DOCUMENT CHANGE REQUEST

DCR number 449	Changes required for: N/A	Originator: Benoit Cornanguer
Date: 2008/12/04	Date sent: 2008/12/04	Organisation: CNES
Status: IMPLEMENTED

Title:	Diodes Switching, based on types 1N5807 through 1N5811		
Number:	5101/013	Issue:	1

Figure 2(b)- Variant 11 to 12 - Leadless Chip Carrier 2 (LCC2B) – 2 Terminal

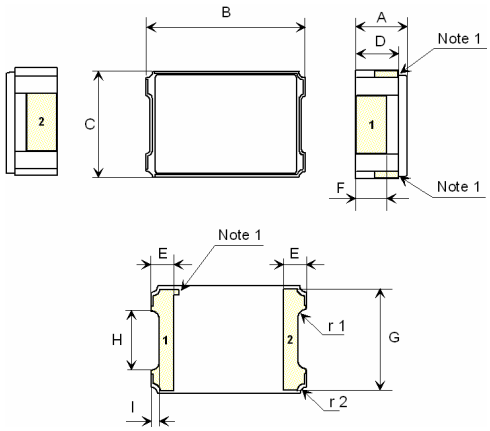
Ref	Dimensions					
	Millimeters			Inches		
	Min	Typ	Max	Min	Typ	Max
A(2)	2.04	2.23	2.42	0.080	0.088	0.095
B	5.27	5.40	5.60	0.207	0.213	0.220
C	3.49	3.62	3.76	0.137	0.143	0.150
D	1.71	1.90	2.09	0.067	0.075	0.082
E	0.48		0.71	0.019		0.028
F	1.4			0.055		
G	3.32			0.131		
H	1.82			0.072		
I	0.15			0.006		
r1	0.15			0.006		
r2	0.20			0.008

Notes:
1. The anode is identified by metallization in two top castellation and by the index mark on the bottom metallization n°1.
2. Measurement prior to solder coating the mounting pads on bottom of package.

Justification .
Variant 11: new ST variant introduction with LCC2B package
Variant 12: new ST variant introduction with LCC2B package
